Product Change Notice (PCN)

PCN Number: PCN-0374303R-01

Product(s) Affected: *CPE-267*

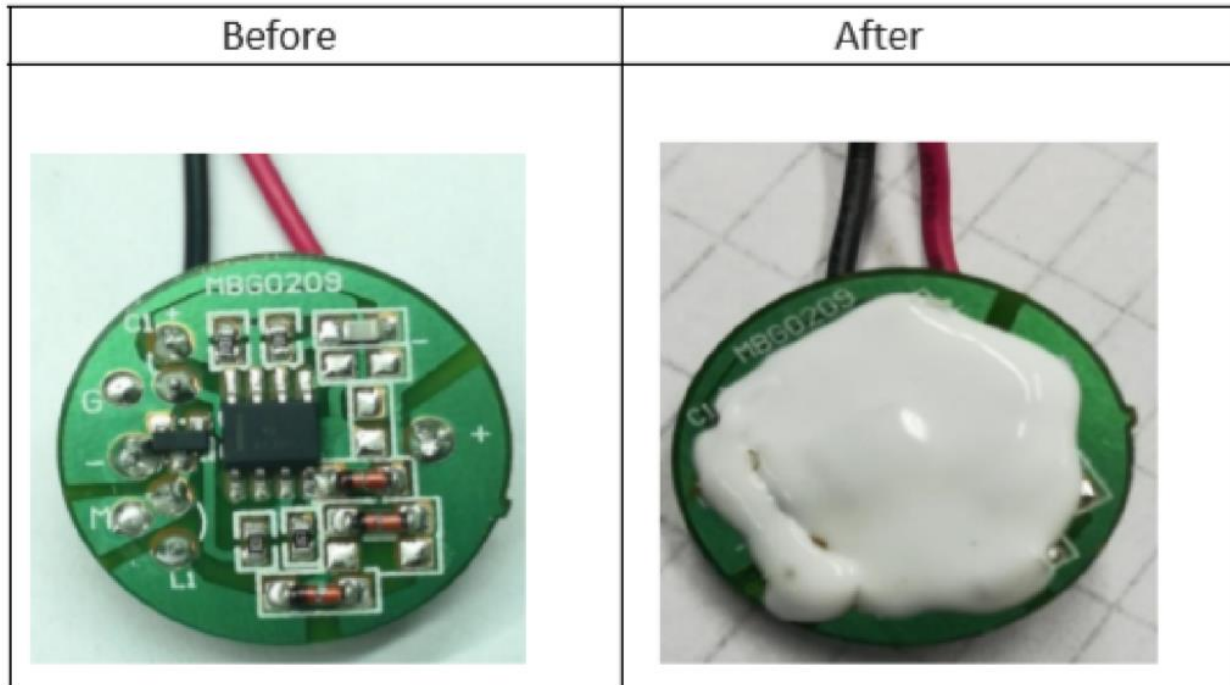
Description of Change: *Addition of white protective glue to PCB, covering components and protecting solder joints.*

Additional Information: *No change to fit or function. Form has been altered.*
